CITY OF TACOMA
Public Work Engineering Division

ADDENDUM NO. 2

Request for Bids Specification No. PW20-0023F
Streets Initiative Package #22

SHEET C-10 OF C-18

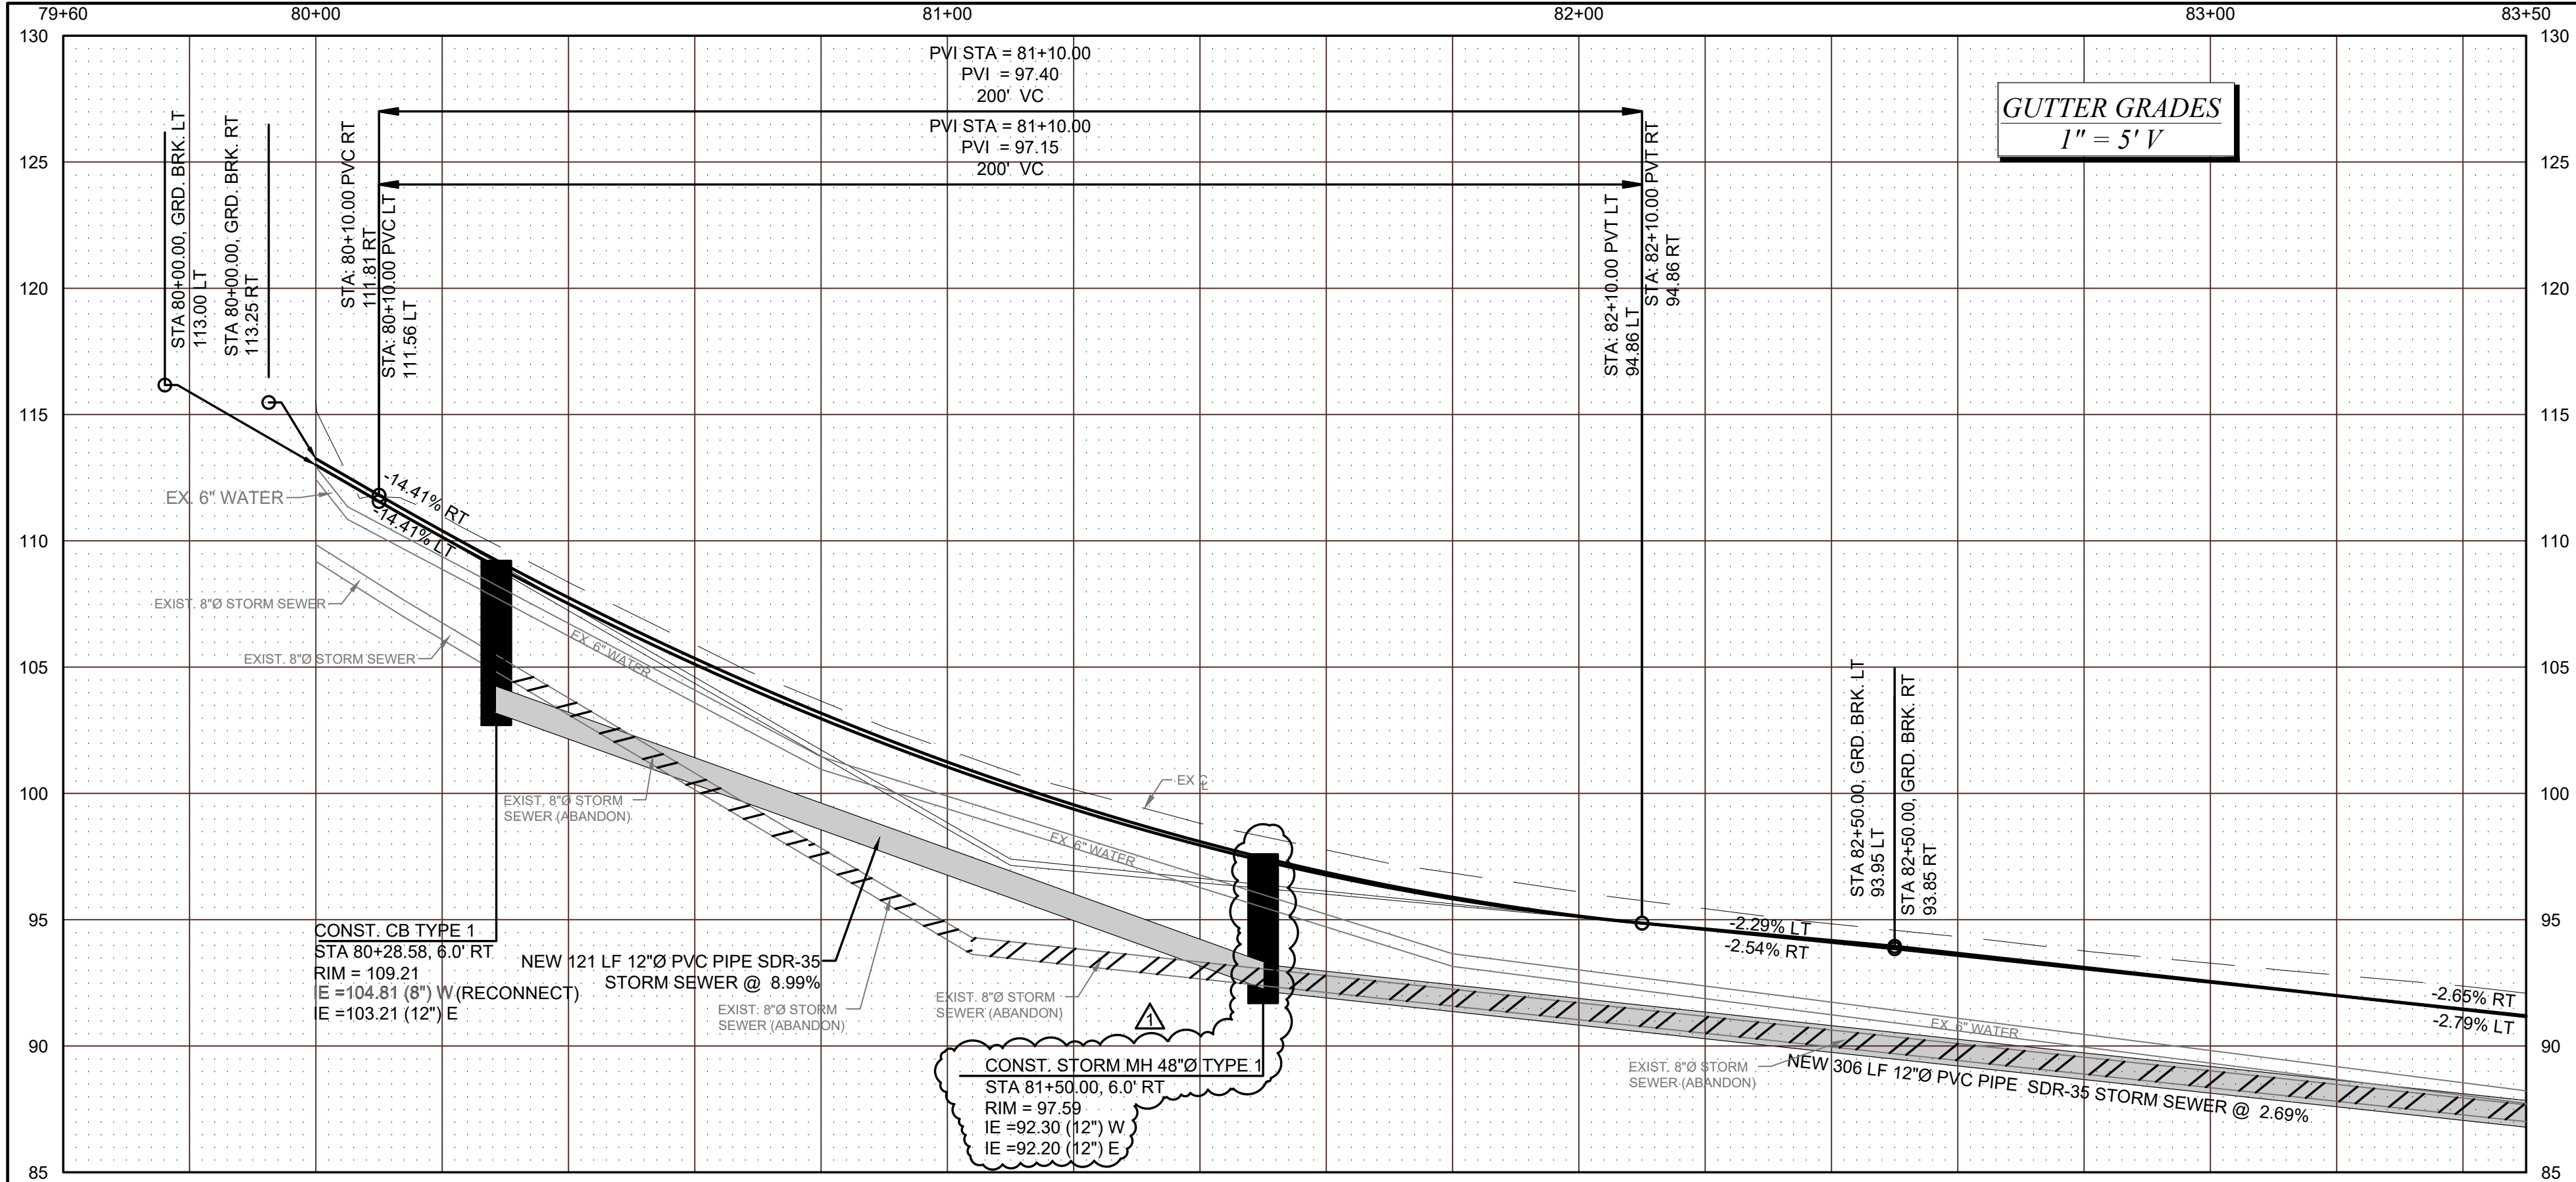
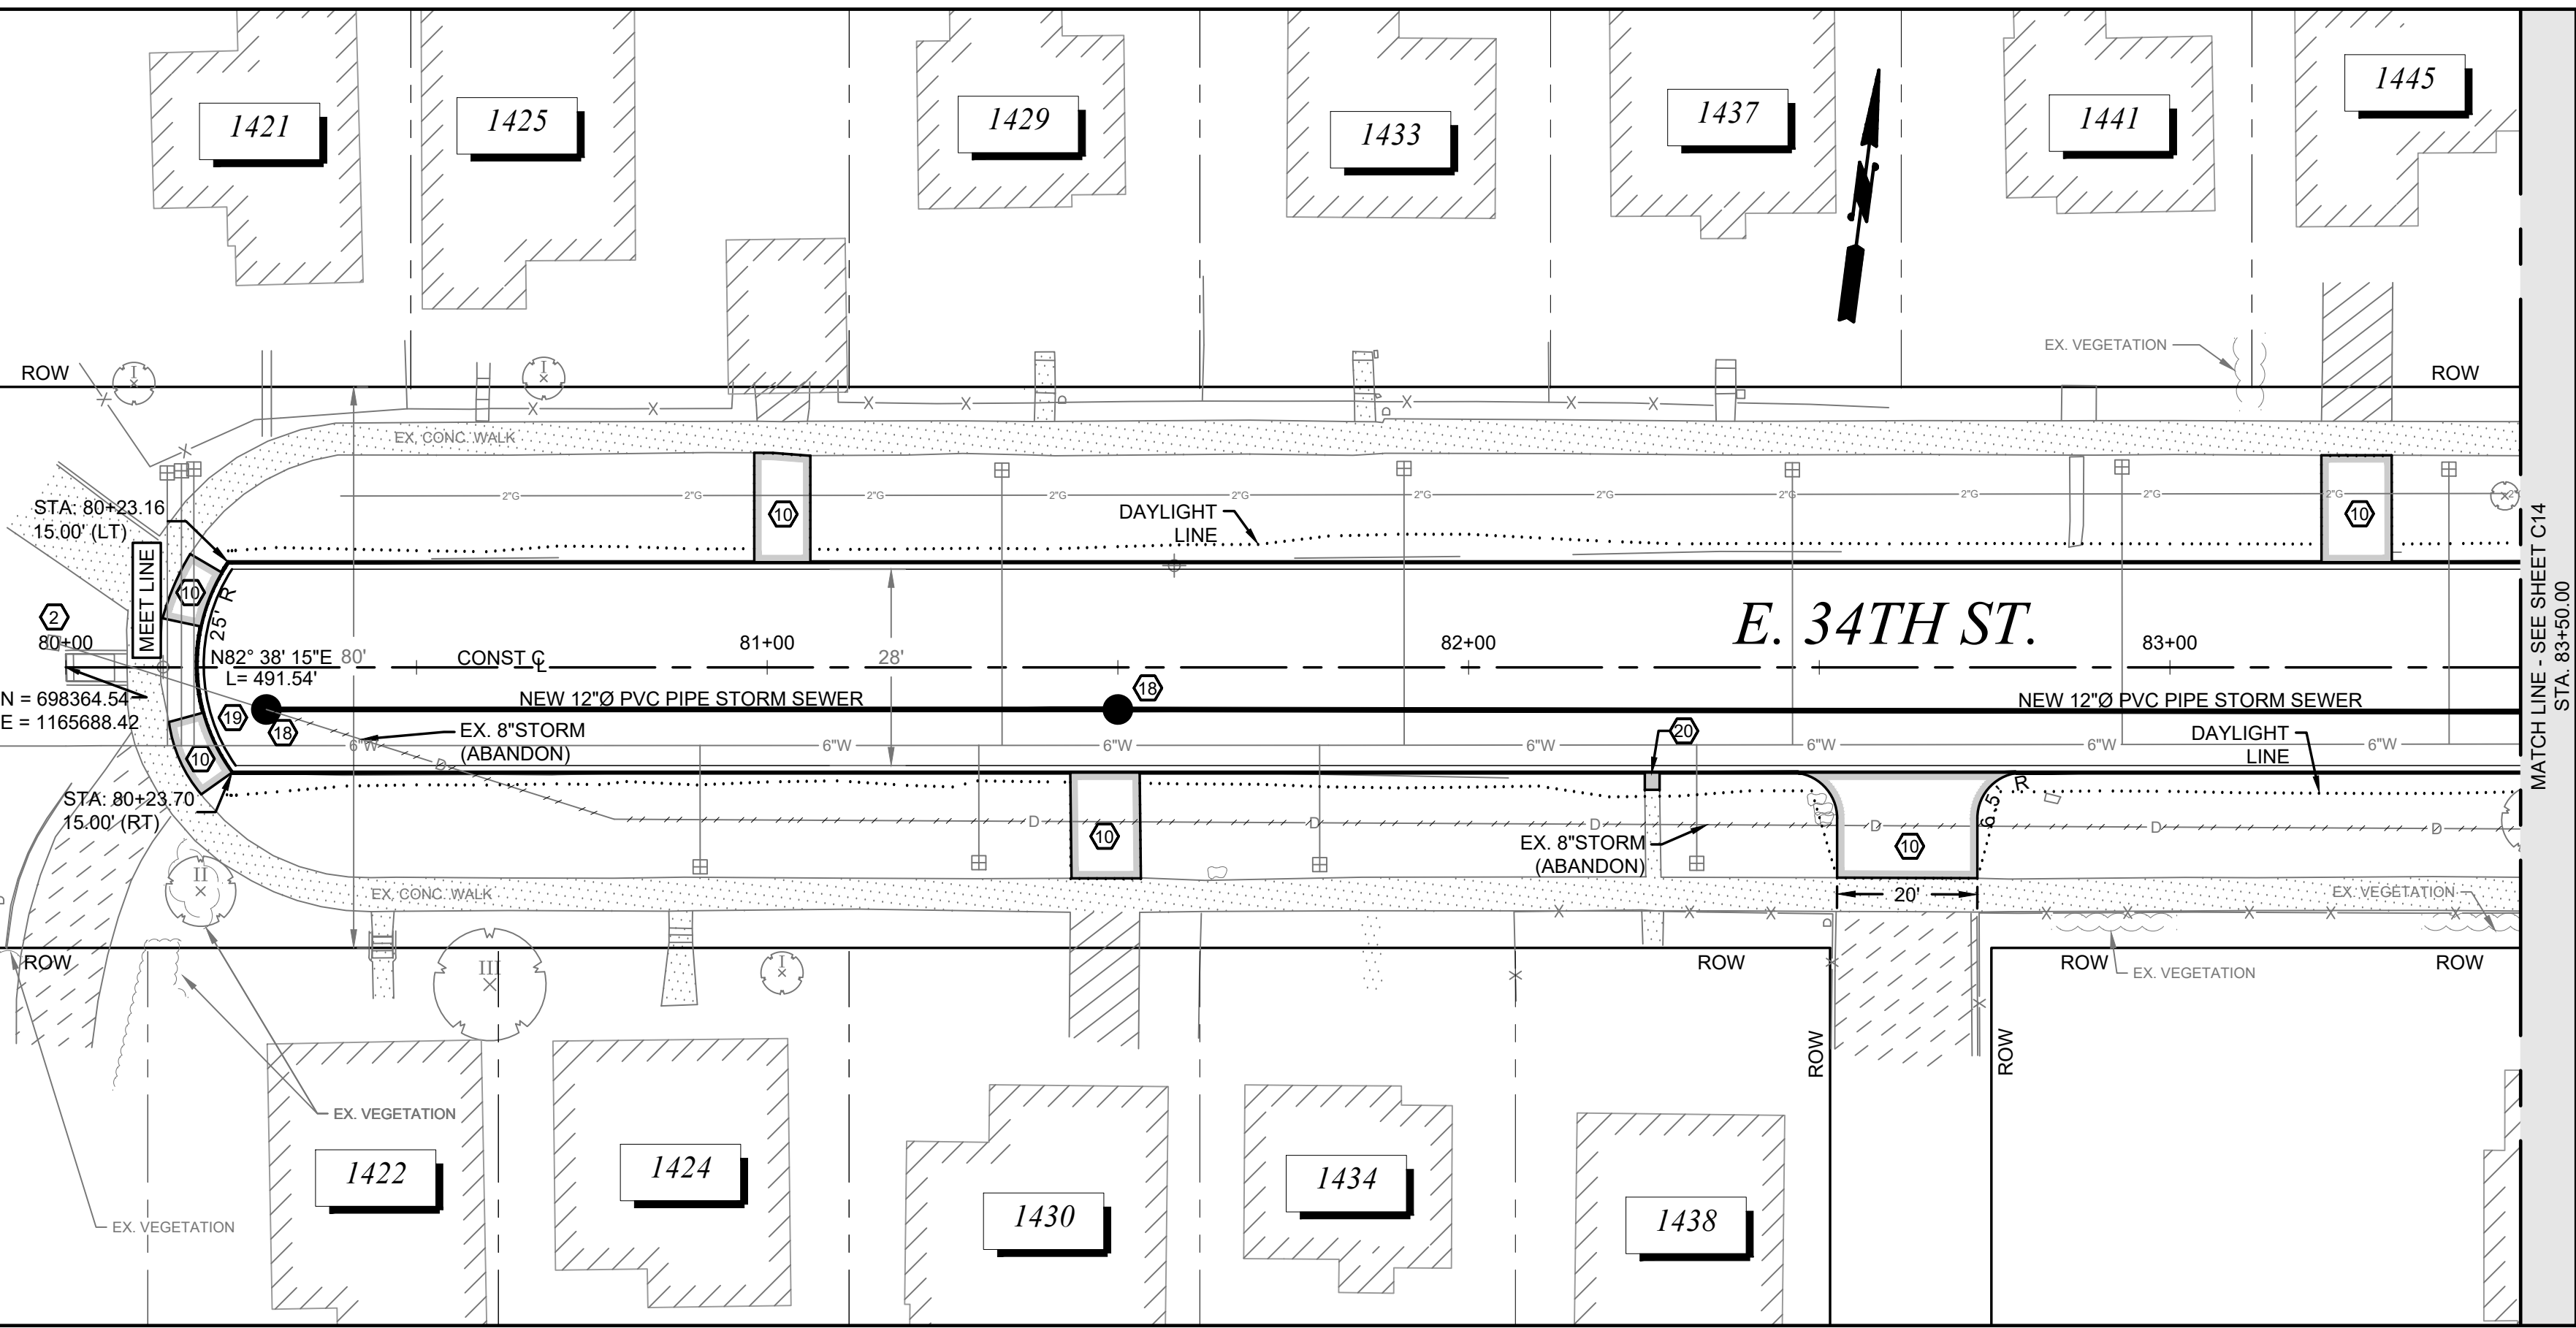
Q. Bid item No. R30 is for 8 each Manhole 48 in. diam. Type 1, Bid item No. R31 is for 2 each Manhole 48 in. diam. Type 3. Yet on the plans all 10 Manhole 48 in. diam. Are called out as type 1 in the profile. In the construction notes you don't even have a call out for a Type 3 manhole.

Q. The two CB Type 1 on sheet C-5 in the intersection, & the two CB Type 1 on sheet C-7 also in the intersection, & the two CB Type 1 on sheet C-10 in the intersection are not labeled vaned grate or combination inlet like the rest of them are. And since there is a large price difference between the two different castings can you please clarify which types these are please.

A. The two type 3 manholes are labeled in the profile view. One on sheet C-10, the other is on sheet C-7 for which the City will issue a new plan sheet

A. The City will issue new plan sheets to address this issue.

Replace plan sheet C-10 in its entirety and replace with the following attached labeled Addendum #2.
